NOTICE OF A TYPE II DECISION ON A PROPOSAL IN YOUR NEIGHBORHOOD

CASE FILE NUMBER: LU 15-199413 AD

Site Address: 1235 SE REYNOLDS ST

The applicant has converted a detached garage into an accessory dwelling unit (ADU). The ADU maintains the footprint of the garage, but a (108 square foot) second story loft was added when the structure was converted; this loft is proposed to be removed. The total floor area of the ADU is 200 square feet.

CASE NO. LU 15-199413 AD
EXHIBIT C-1

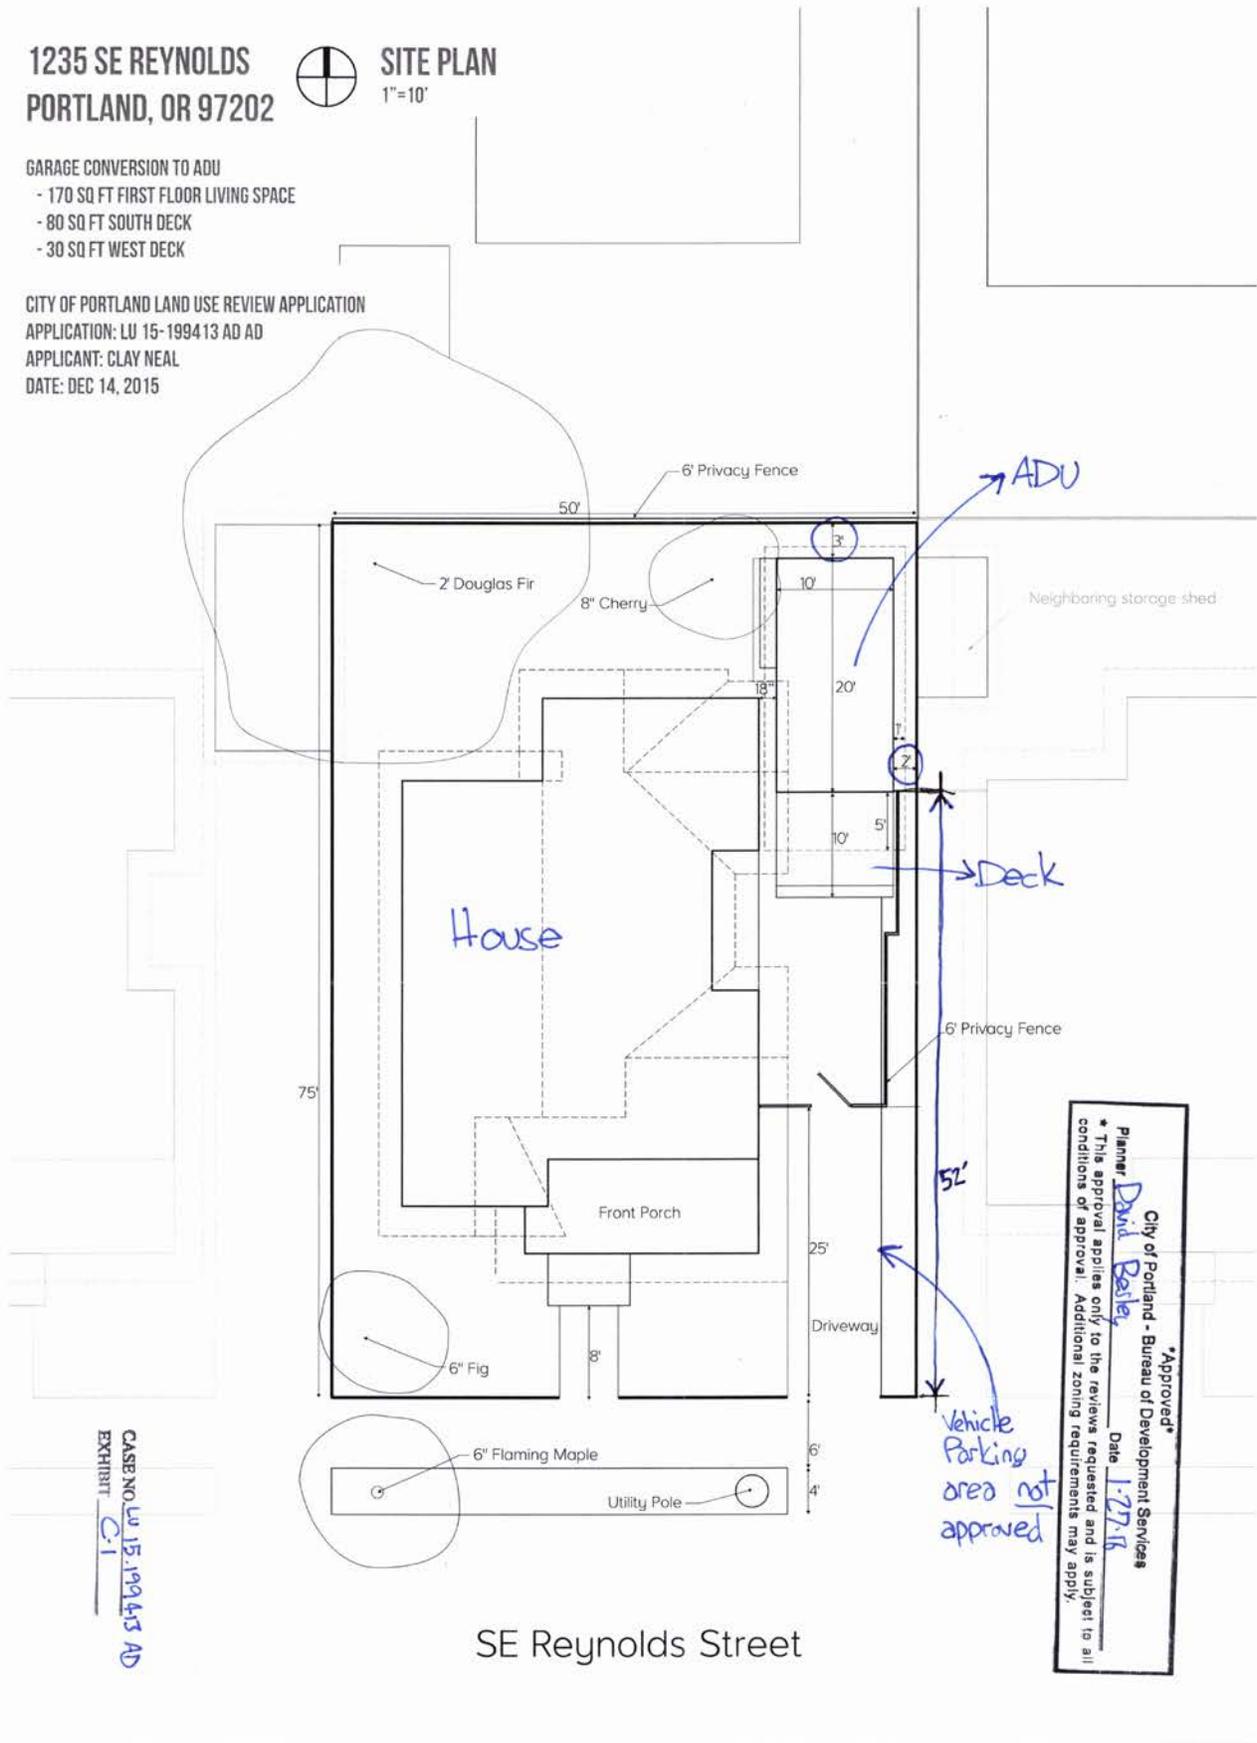
Note: This Adjustment approval and approved site plan does not approve the vehicle parking area as shown. Parking is not allowed within the first 10 feet from a front lot line (33.266.120.C.1.a) and the standard parking space size for a house is 9 feet by 18 feet (33.266.120.D.1). There is a fence at 25 feet from the front lot line which must be shifted at least 3 feet to the north (for a minimum 28 feet in length) to accommodate parking requirements. At the time of building permit submittal, the applicant must include a revised site plan to reflect vehicle parking changes.

CASE NO. LU 15-199413 AD
 EXHIBIT C.2

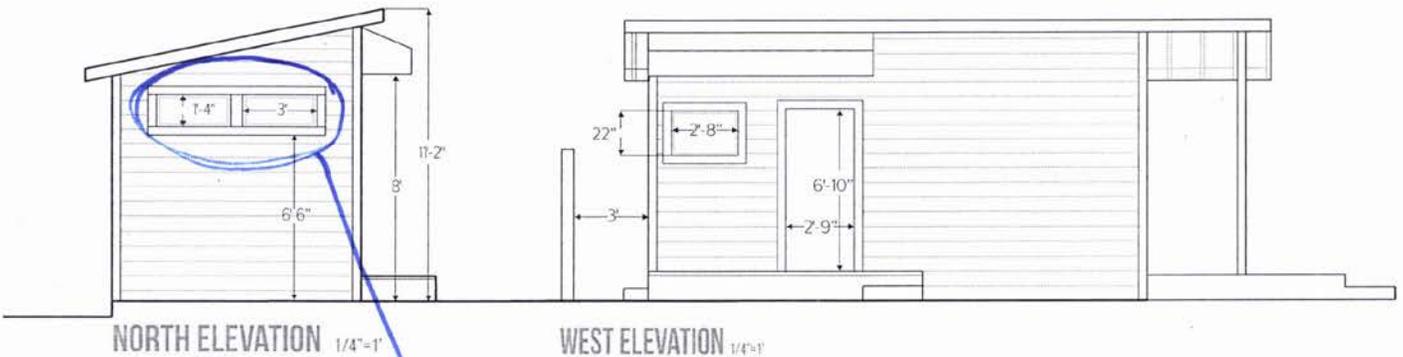
Unless the applicant can demonstrate that the north wall is farther than 3 feet from the property line, the two windows proposed on the north elevation will likely have to be removed because wall faces that are 3 feet or closer must be fire rated and cannot have openings (including windows).

wall faces 3' or closer
 must be fire rated
 and cannot have openings
